CITY PLAN COMMISSION STAFF REPORT

CD-CPC-2025-00133

Executive Park Lot 6 Major Amendment

Rezoning to UR - Major Amendment

SHEET TITLE
LANDSCAPE PLAN

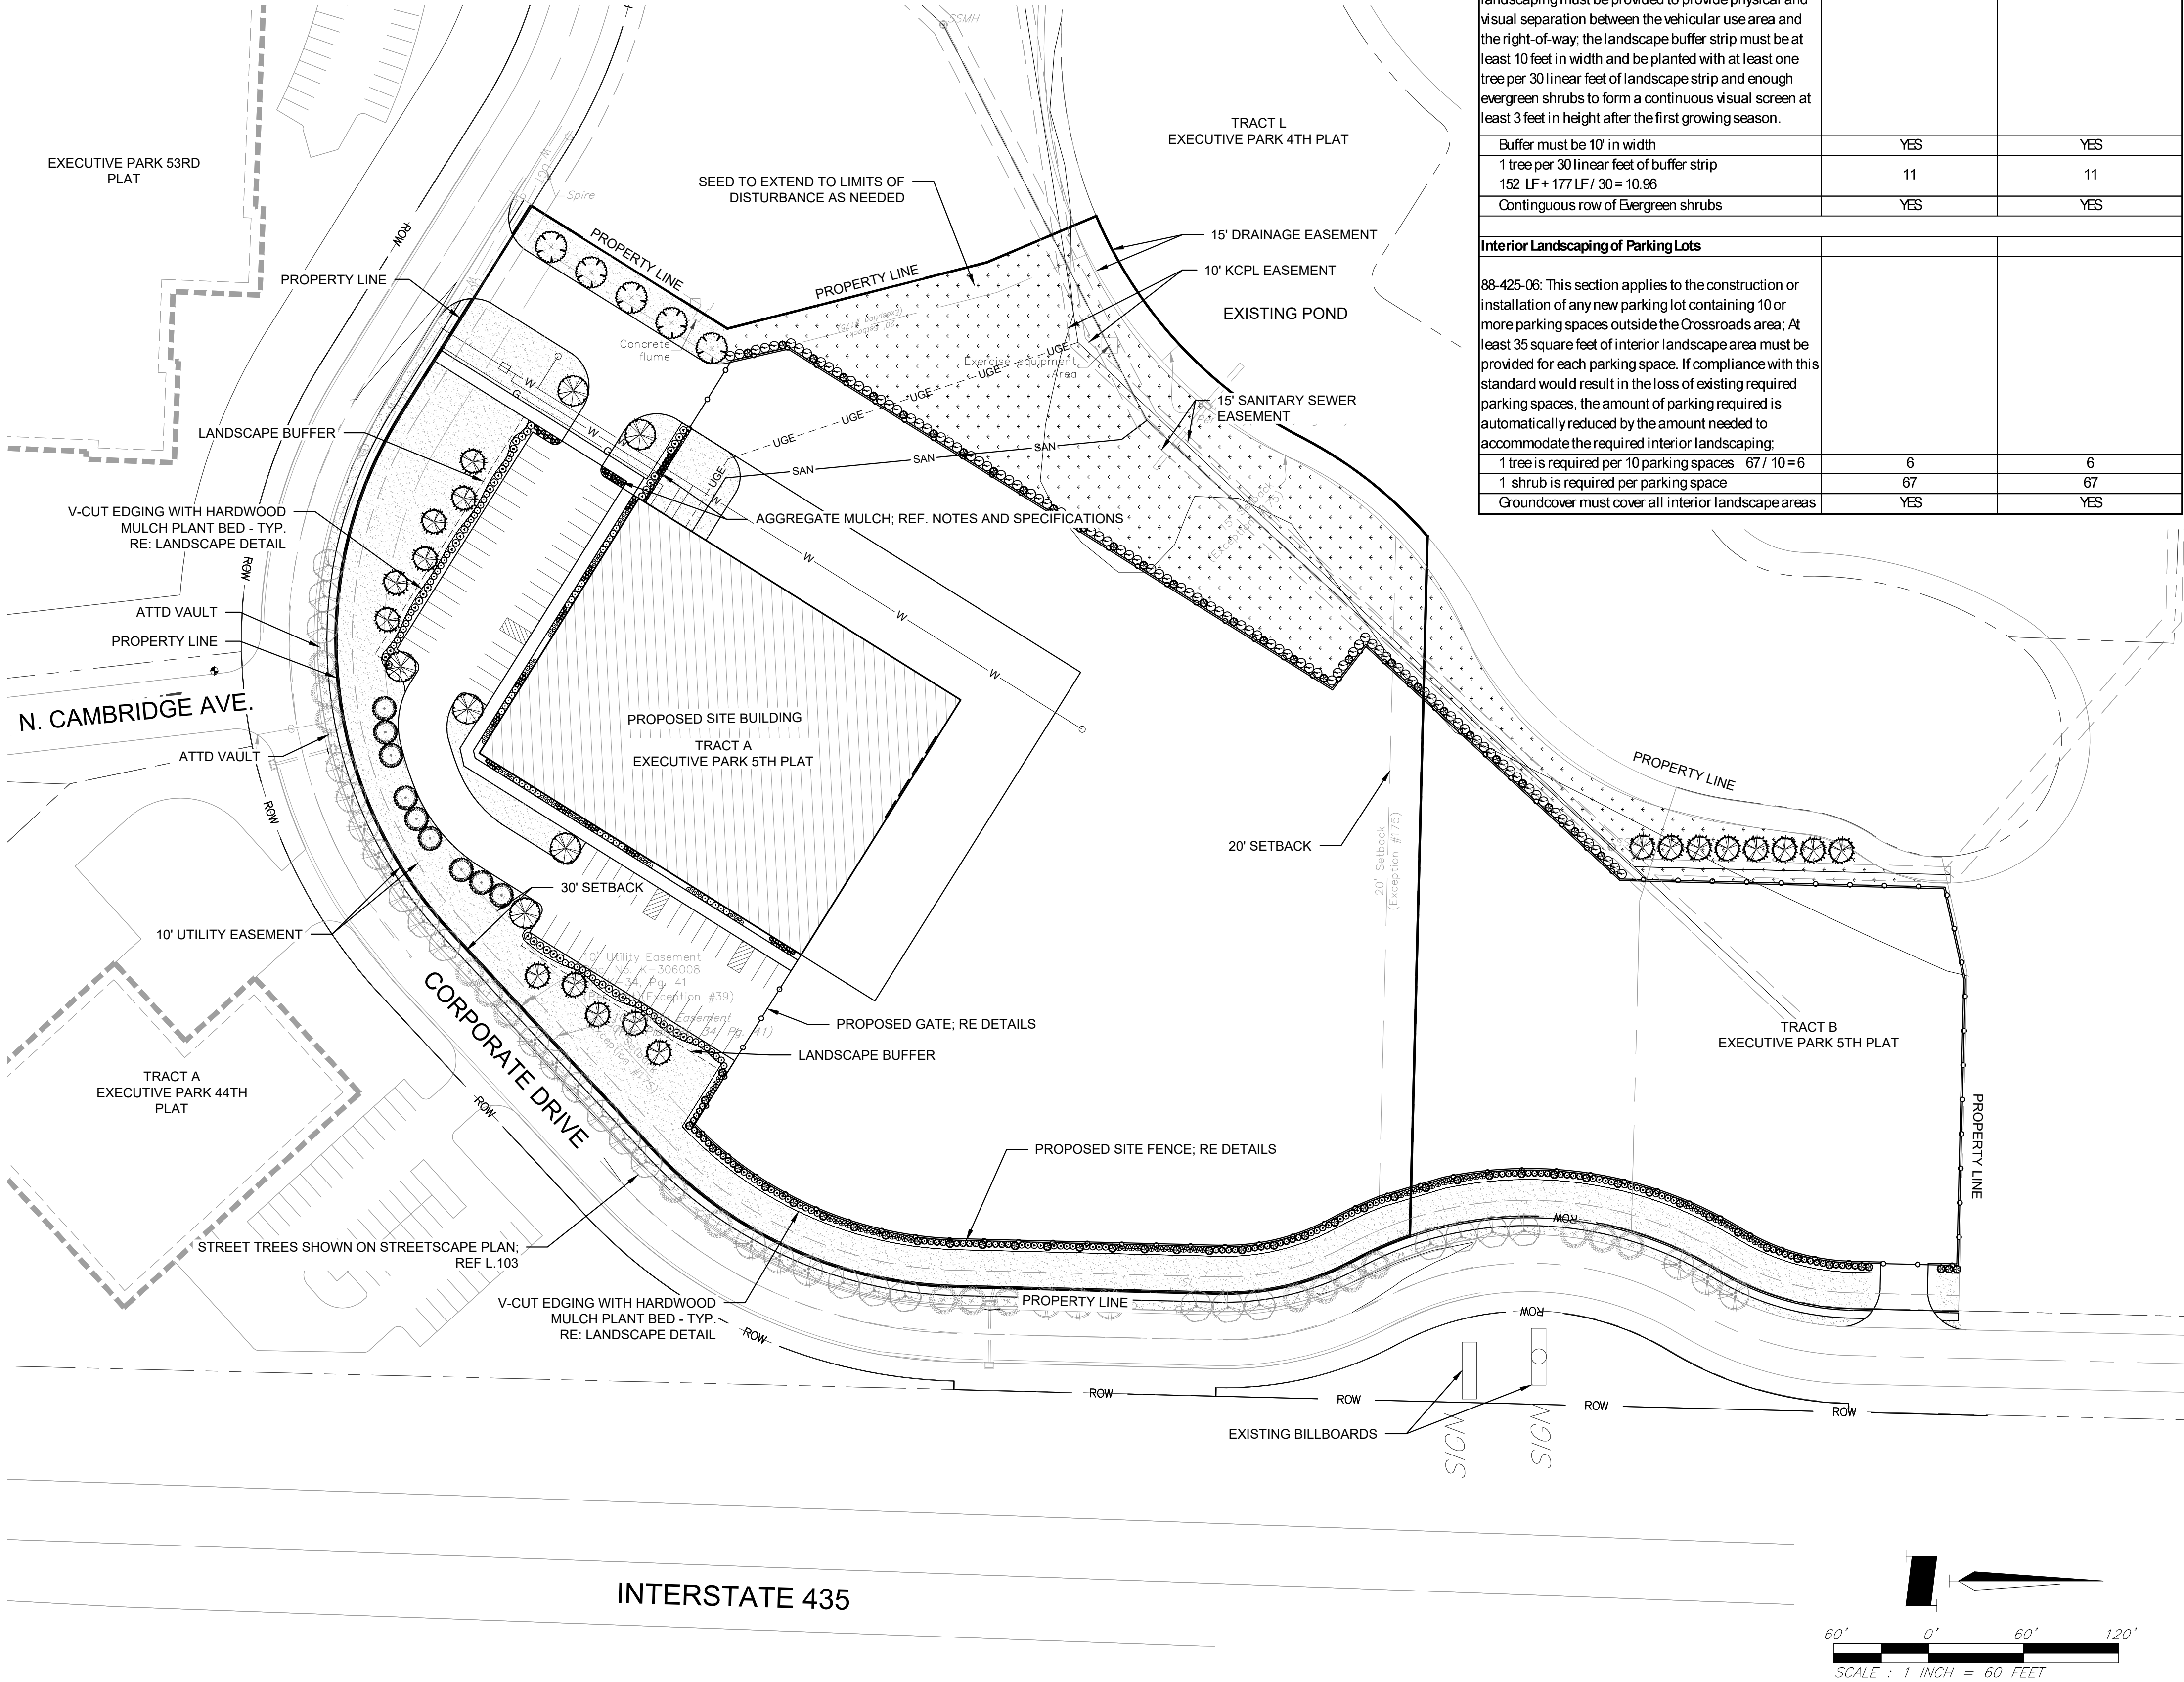
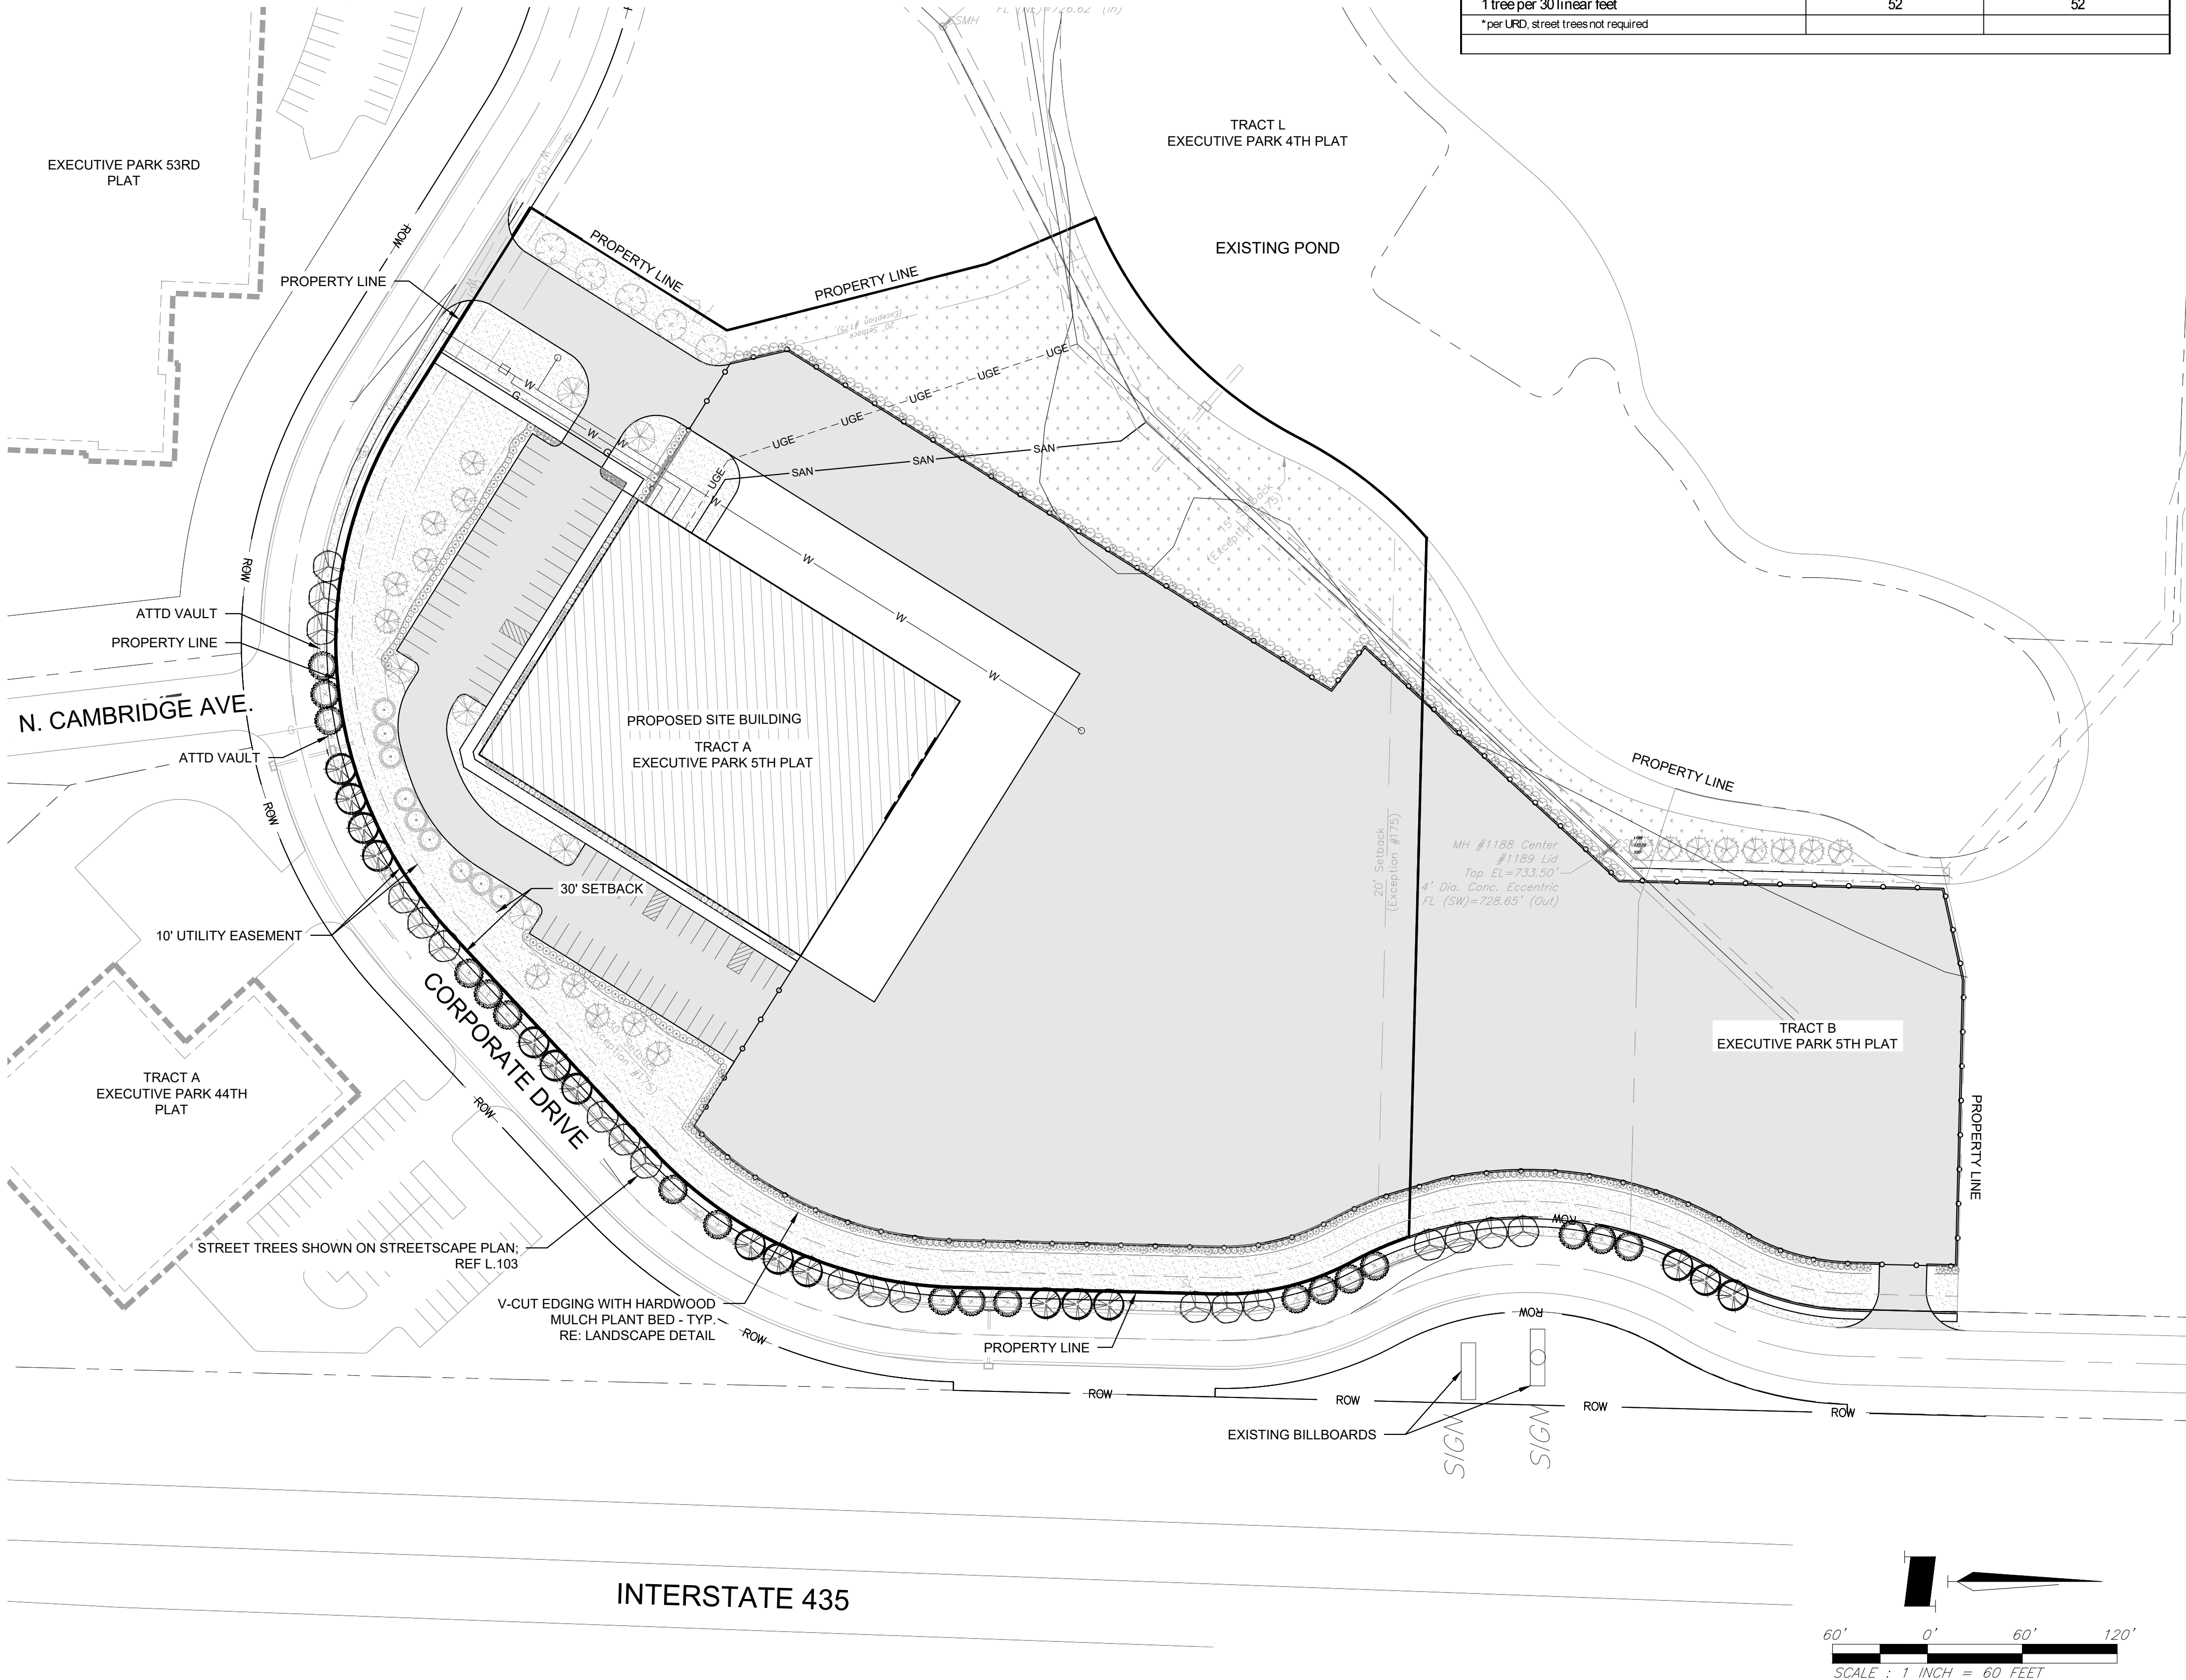
This site is appropriate for light industrial uses, but the applicant should keep in mind that the neighboring use is a charter school. To improve the project's Playbook and Area Plan alignment regarding design, the building should have large windows on all four elevations. The concern is that no one inside the building can see if there's an issue outside the building. Additionally, the applicant should include the robust fencing and landscaping shown in the

first submittal even though it was left out of the second submittal. – Luke Ranker, Community Planning Division, 4th District Planner
